**P L A N N I N G S U B -
C O M M I T T E E**
Wednesday 2 November 2022
at 6.30 pm Council Chamber, Hackney
Town Hall

**SUPPLEMENTARY PAPERS – ADDENDUM
PAPERS**

ITEM 6: 2022/1946: Portico City Learning Centre, 34 Linscott Road, Hackney, London, E5

ADDENDUM TO STRUCTURAL REPORT – DEMOLITION AND EXCAVATION

Sketch 1 – Structural proposal next to South Wall of the Crypt

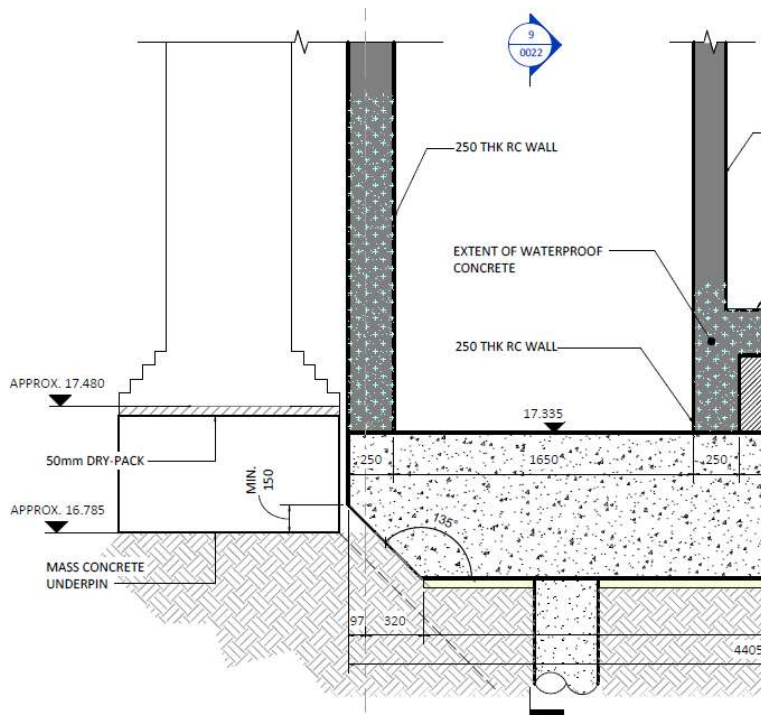
The site findings confirmed that the footings in the area are above the structural slab level in the area next to the lift of the proposed building which is 17.335 and that underpinning will be required for the area. For the underpinning to be done in safe and effective manner the full width of the wall has to be underpinning. Considering the load paths and the structural integrity we have specified that the exposed arches should be bricked to the full width of the prior to any underpinning. This will ensure that the loads are transferred to the footings and the new underpin without relying on old arch. At the top of the new and the existing masonry infill well rammed drypack should be appropriately installed. Please refer to the photograph below with the work in progress from site.

After the remedial works are installed the masonry walls projecting south of the crypt can be carefully removed and the walls should be underpinned to ensure that they are not undermined. Please refer to the sketch below for the proposed structural solution in the area.

With the suggested detail we consider that the existing structure will be appropriately supported, and the structural integrity is not affected. As the loads to the existing building are not changed, we do not consider that any settlement will appear under the new underpin and we do not expect any damage to the existing structure.
